**SUBJECT: WATTS BAR NUCLEAR PLANT UNIT 2 CONSTRUCTION - NRC INTEGRATED
INSPECTION REPORT 05000391/2010604**

SUBJECT: WBN NUCLEAR PLANT UNIT 2 CONSTRUCTION - NRC INTEGRATED
INSPECTION REPORT 05000391/2010604

Facility: Watts Bar Nuclear Plant, Unit 2

FIGURE 1

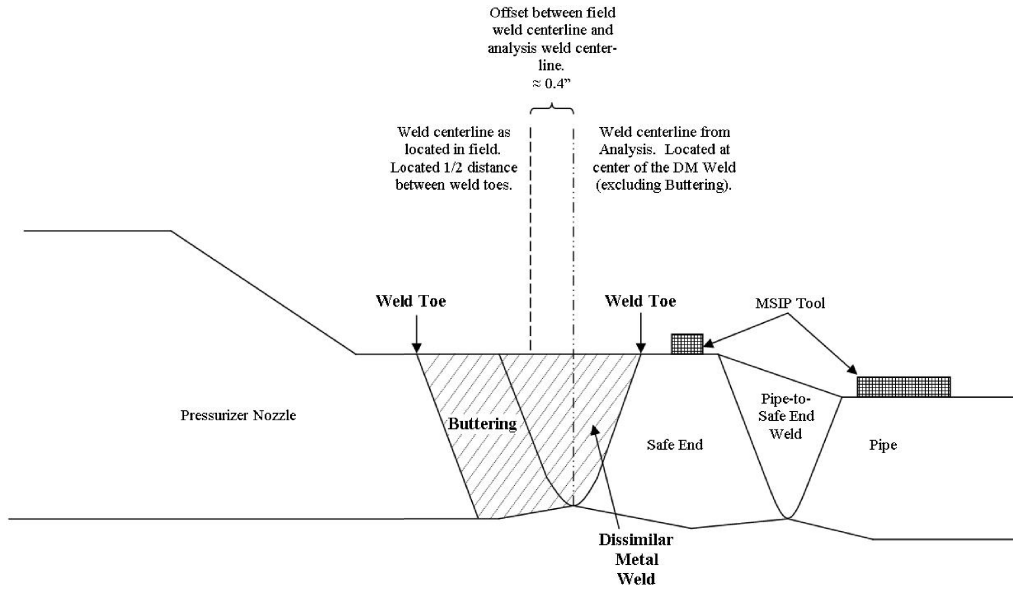
Correct placement of the clamp in the field requires that the same weld centerline used in the stress analysis calculation be marked on the exterior of the weld. Procedure PI-901153-01, "Watts Bar Unit 2 Mechanical Stress Improvement Process (MSIP) Applied to Pressurizer Nozzle to Safe End Welds," was the controlling procedure for the MSIP process. This procedure required the weld centerline to be located and marked. Per Westinghouse Interface Document (25402-011-V1A-MG00-01838-002), paragraph 5.5.3, TVA was required, in part, to "identify and mark the centerline of each dissimilar metal weld (excluding the buttering region)." Location and marking of the weld centerline in the field was performed by TVA personnel using TVA procedure N-GP-8, "Weld Reference System." N-GP-8 is a generic procedure used to establish a weld reference system for welds and areas receiving surface or volumetric examinations, and was not created specifically for the MSIP process. N-GP-8 directed TVA personnel to determine the weld centerline by locating the weld toes (performed with ET examination) at the carbon steel nozzle-to-butter interface and at the DM weld to safe end interface. The weld centerline was then marked at the midpoint between the two weld toes; however, this centerline marking did not correspond to the same centerline established in the stress analysis calculation because it did not account for the thickness of buttering, or any differences in the weld joint bevels between the safe end and the carbon steel nozzle (see Figure 1 of the attachment for an illustration of the surge line nozzle). A note in procedure PI-901153-01 required PCI QC personnel to verify dimensional measurements required as part of the procedure; however the procedure did not identify a technique (for example, direct measurement from a readily identifiable marking on the weld) or criteria to verify the location of the centerline weld, nor was a tolerance for the weld centerline location provided.

On July 22, 2010, the inspectors observed the process of identifying the weld centerline for the pressurizer surge line nozzle DM weld (2-WP-10- SE) using the same procedures described above. However, in this instance NuVision Engineering (contractor) personnel performed the process in conjunction with TVA personnel. Weld toe markings had previously been applied at the safe end weld toe (see Weld Toe B on Figure 1), but the carbon steel nozzle weld toe had not been marked (see Weld Toe A on Figure 1). The inspectors observed TVA personnel apply a low-stress "V" stamp to the carbon steel nozzle weld toe. This location was easily identifiable with the naked eye and, therefore, ET examination was not required. The inspectors then questioned NuVision Engineering personnel on the method to be used to locate the weld centerline and observed the identification of the weld centerline using a process of measuring the distance between the previously located toes of the weld and marking one half the distance between them. This process was consistent with procedure N-GP-8. The centerline mark was confirmed as correct by PCI QC personnel. However, the joint configuration of the surge line nozzle included a layer of weld butter on the carbon steel nozzle side (see Battering on Figure 1), which resulted in an offset between the field marked centerline and the centerline required by the stress analysis (4387-4-001-01, NuVision Engineering, "Analytical Verification of MSIP for Pressurizer Surge Nozzle to Safe End Weld Watts Bar Units 1&2," Revision 1) that was approximately 0.40", and outside the allowable tolerance of ± 0.25 " provided by the stress analysis calculation. The licensee did not apply MSIP to the pressurizer surge line, and began development of a detailed procedure specifically created to mark the correct weld centerline for the pressurizer surge line nozzle.
